Hardware data sheet section III addendum

ET1810 / ET1811 / ET1812 and ET1815 / ET1816

EtherCAT[®] Slave Controller IP Core for Altera[®] and AMD[®] FPGAs

Section III – Addendum
Design flow compatibility, FPGA device support, known issues

Figure 1: Additional H_REG for RGMII inputs using Altera DDR input cells

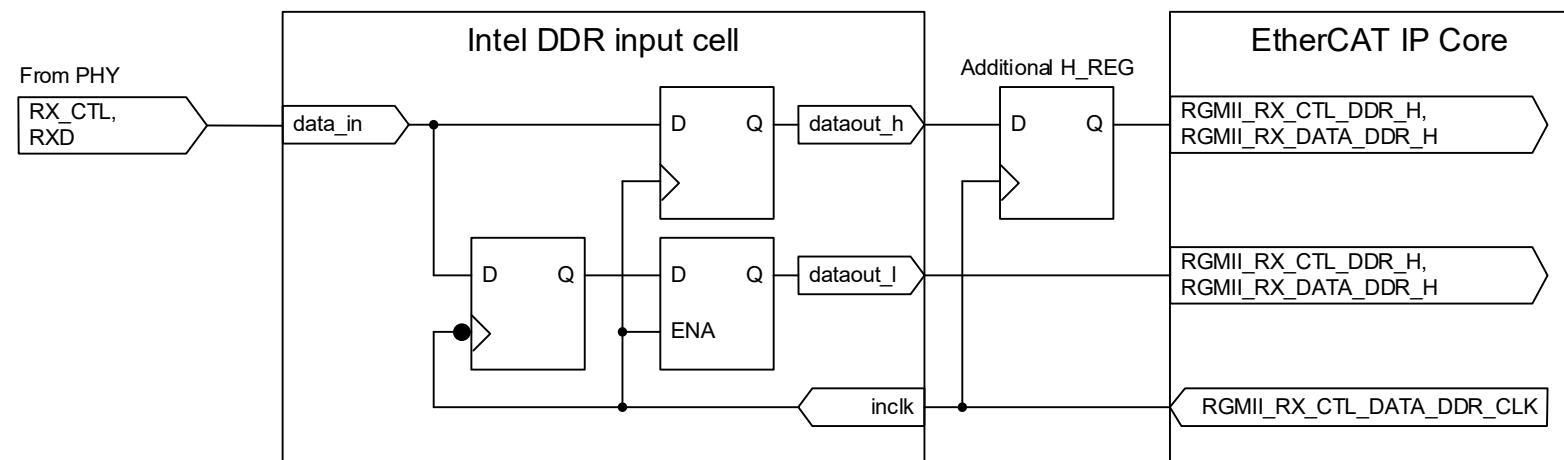
2.4.2.1 EtherCAT IP Core before V3.0.10 Patch 3: DE2-115 NIOS RGMII example design is missing a register for DDR input signals

The EtherCAT IP Core evaluates RGMII DDR input signals at the rising clock edge, and it expects that the DDR_H input was sampled before the DDR_L input. For RX_CTL, this means that DDR_H contains RX_DV, while DDR_L contains RX_ER for the same receive clock cycle.

The DE2-115 NIOS RGMII example design uses an Altera DDR input cell which uses a reversed DDR_L/DDR_H ordering. Due to a certain behaviour of the PHYs on this boards, this will not cause problems, but using the example design for other PHYs can result in receive errors.

An additional register has to be added to the DDR_H path for each RX_CTL/RX_DATA[3:0] signal, according to the following schematic:

Example code for the additional H_REG for one port (duplicate and update port numbers for additional ports):

```
Port0_H_REG: process(RGMII_RX_CTL_DATA_DDR_CLK0)
begin
  if rising_edge(RGMII_RX_CTL_DATA_DDR_CLK0) then
    RGMII_RX_CTL_DDR_H0_reg <= RGMII_RX_CTL_DDR_H0;      -- port 0 receive clock
    RGMII_RX_DATA_DDR_H0_reg <= RGMII_RX_DATA_DDR_H0;    -- H_register for port 0 RX_CTL
  end if;                                               -- H_register for Port 0 RX_DATA[3:0]
end process;
```
